SERVICE BULLETIN

PURPOSE : INFORMATION	ISSUE NO. : MSB-10E13_17-001	DATE : 2010-06-05
SUBJECT : DPF-RELATED SERVICE PROCEDURES FOR 4N1	<MODEL> <M/Y>	
GROUP : FUEL/ENGINE & EMISSION CONTROL	(EUR) See following 2. Applicable Manuals table.

On 4N1 engines, some DPF-related service procedures are revised as shown below. This Service Bulletin contains the details of these changes.

DIAGNOSIS PROCEDURE**STEP 1. Replace the exhaust centre pipe.**

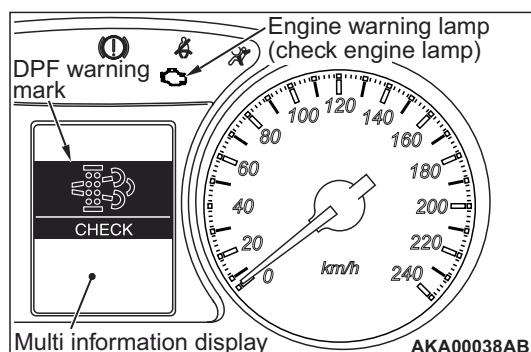
Code No. P2463: No chance of forcible regeneration of DPF**FUNCTION**

- The engine-ECU monitors the input signals from sensors to estimate the PM amount loaded to the DPF inside.
- If the PM is loaded more than the specified amount, the DPF regeneration is automatically executed under certain conditions in order to eliminate the PM.
- If the PM is excessively loaded, the engine-ECU should not execute the automatic DPF regeneration. At that time, the engine-ECU should store the diagnosis code P1498. It makes the engine warning lamp illuminate and allows the DPF warning mark to be shown.
- If the engine-ECU estimates that the amount of accumulated PM will increase and reach the level where the DPF cannot be regenerated after the diagnosis code P01498 is stored, the diagnosis code P2463 should be stored.

1. Replace the exhaust centre pipe.
2. Erase the diagnosis code.
3. Use the M.U.T.-III to perform the initialization item No.40 "Exchange Service". Initialize the learning values. (Refer to GROUP 00 – Initialisation Procedure For Learning Value In Common Rail Engine <4N1>).
4. Reconfirm whether the diagnosis code is set.
